Modification Recommended Service Note

P5008A Keysight Streamline USB Vector Network Analyzer

Potential lifted front panel overlay

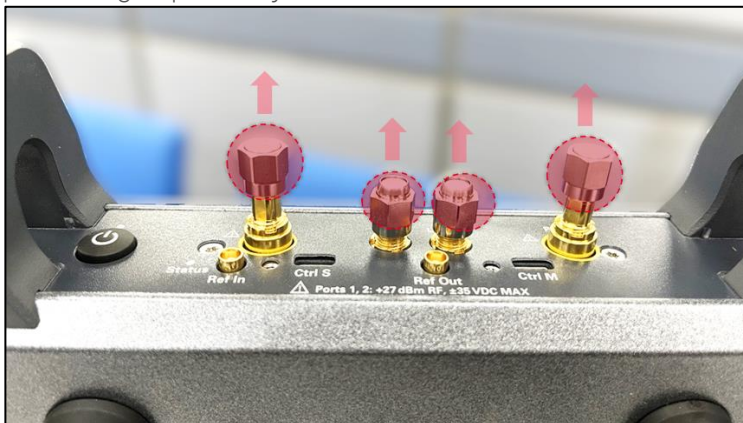
Keysight streamline series vector network analyzer (VNA) of serial number range identified in service note cover page might potentially exhibit the following lifted front panel overlay symptom.

Apart from cosmetic imperfections, the lifted front overlay could have led to non-fully attached *Ctrl S* micro-HDMI cable connector in multi-VNAs setup configuration.

-> Apply this service note only if end users' VNA is exhibiting the following symptom.

Procedure to replace the front panel overlay.

1. Remove the front handles. Detach the 50-ohm termination (LO-In, LO-Out, Port 1 & Port 2) or protecting caps if they are attached to the VNA.

2. Pry open the existing front panel overlay and remove it from front panel.
3. Clean the metal surface thoroughly and ensure it is free of adhesive residue.
4. Affix the new self-adhesive front panel overlay onto the metal surface.
5. Reinstall (reuse) the 50-ohm terminations or protecting caps accordingly.

6. Reinstall (reuse) the front handles.
